Authors response to anonymous referee #1 on “Evaluation of a field-deployable Nafion™-based air drying system for collecting whole air samples and its application to stable isotope measurements of CO₂” by Paul, D. et al.

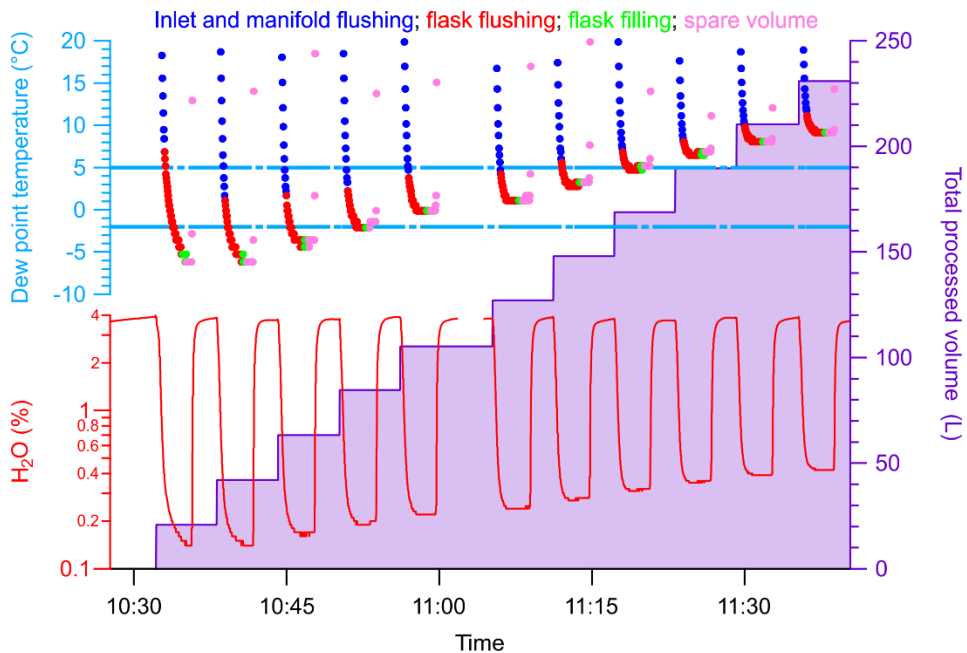
- *Figure 2. The scale for H₂O % needs some attention between 0.1 and 1 as the decimal place is not present.*

Authors response: The figure has been updated:
